CITY OF SAN BRUNO
COMMUNITY DEVELOPMENT DEPARTMENT

Re: Technical Comments on Potential Monopole in San Bruno for the
Proposed Jefferson-Martin 230kV Transmission Line Project
Application No. A0209043 – SCH #20030120066

Responses to Comment Set B – City of San Bruno

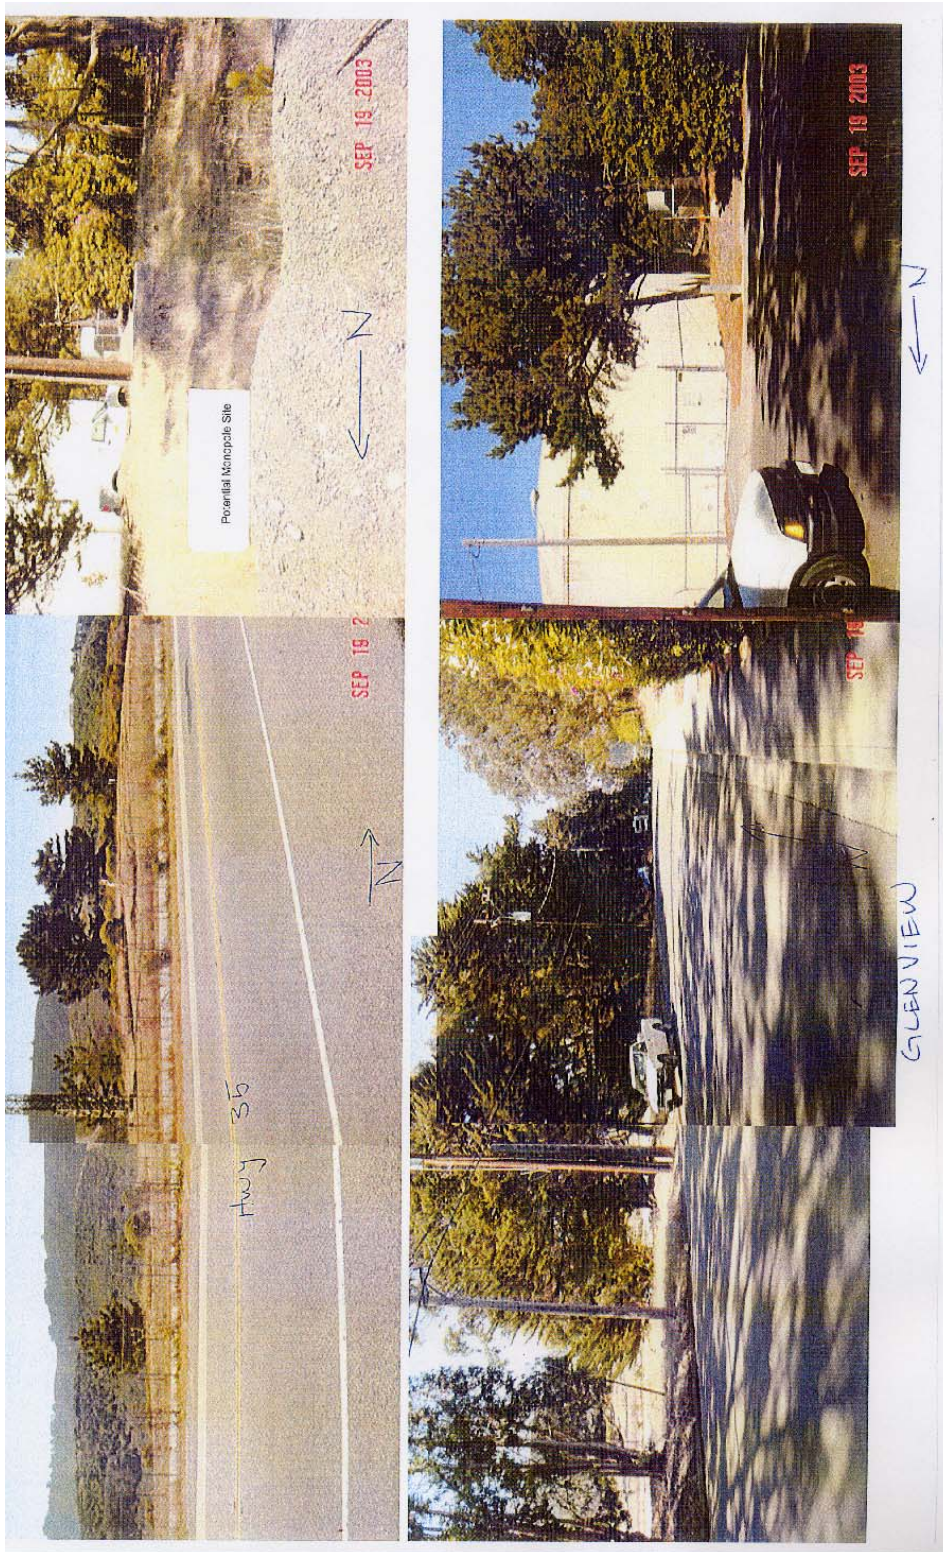
As indicated on the attached reduction of San Mateo County's Assessor's Map #19-28, the potential location for a transition monopole would be located on CalTrans property, generally across from lot 8 (with circle). The width of this section of CalTrans right-of-way is approximately sixty (60) feet, which could accommodate a forty (40) foot base for a monopole. However, CalTrans should be contacted for any restrictions on this property. Also, as previously stated in the August 28th letter, San Bruno requests that any location of a structure in this area allow for the future widening of Skyline Boulevard to two lanes in each direction.

- B-5 Please see Response to Comment B-4.
- B-6 The City's preference for a transition tower monopole (rather than the lower-profile but larger footprint transition station) is acknowledged. In response to this comment, the EIR now considers a third transition tower alternative, described in detail in Appendix 1 (Alternative Screening Report), Section 4.3.1.3.

The site suggested, on the tree-lined divider strip between Skyline Boulevard and Glenview Drive, is owned by Caltrans, so coordination with Caltrans was pursued to determine the feasibility of using this site. Based on these coordination efforts, it has been determined that although Caltrans retains this ROW for potential future expansion of Skyline Boulevard, this expansion is not currently identified on Caltrans' 10-year plan (Caltrans, 2003c). Based on analysis of Caltrans requirements, it appears that use of the eastern edge of the Caltrans ROW could be feasible, allowing PG&E to submit a request for an Encroachment Permit. The

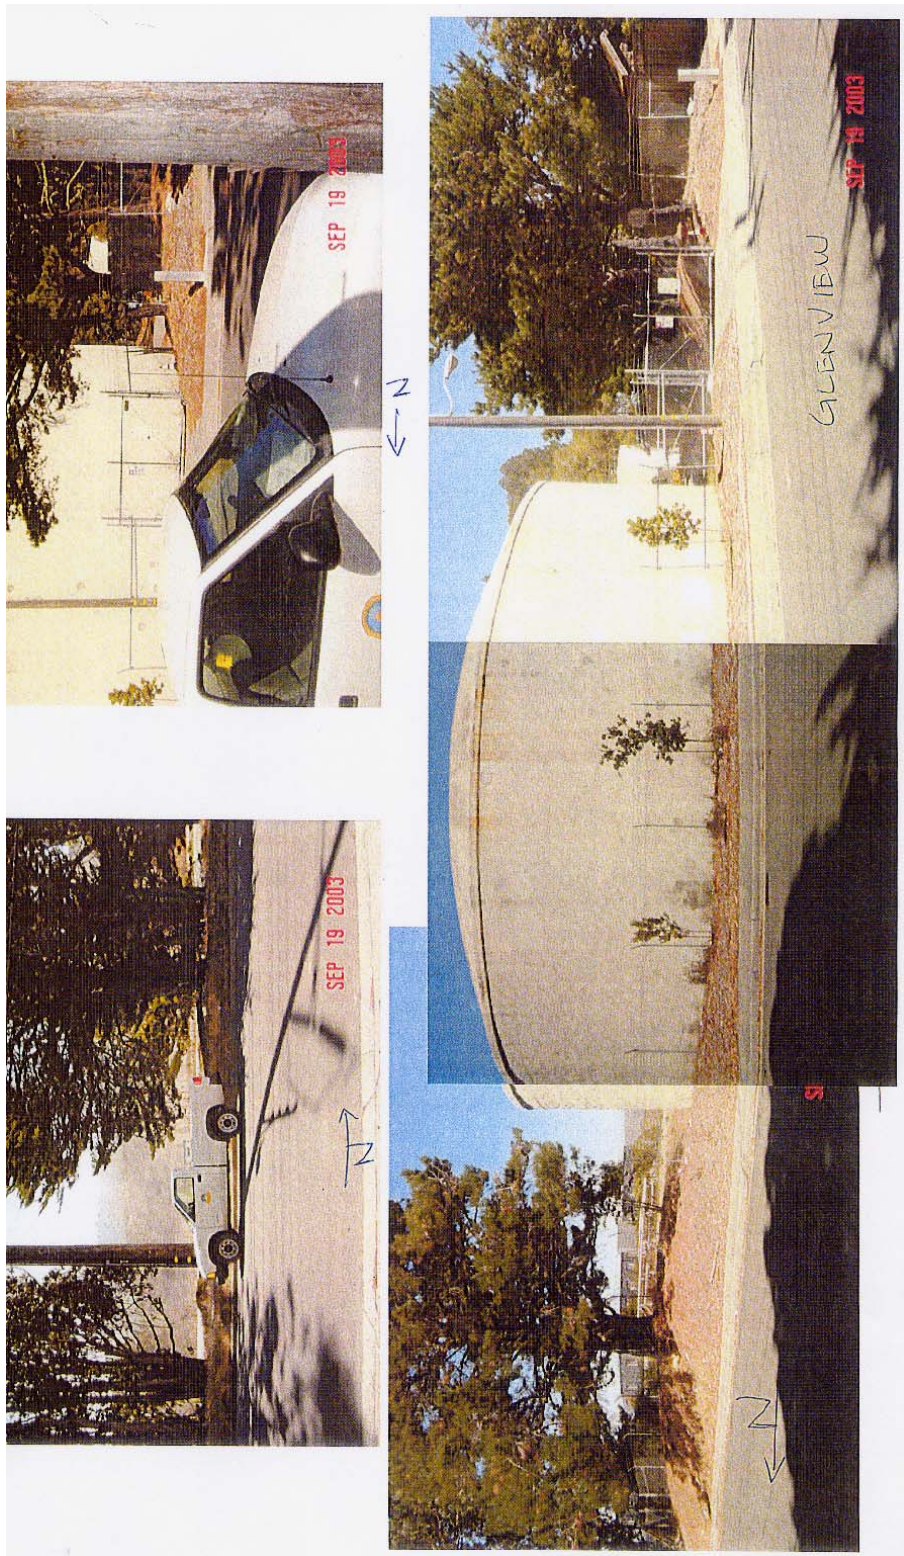
I have enclosed a black-line aerial of the area, marked to show the potential location of a transition monopole, as well as its proximity to the intersection of San Bruno Avenue and Glenview Drive. In addition, I have provided pictures of the area showing the water tank, the subject CalTrans property, and the area across Skyline Boulevard. Note that the City's white truck is parked on the Glenview Drive side of the potential location of a transition monopole.
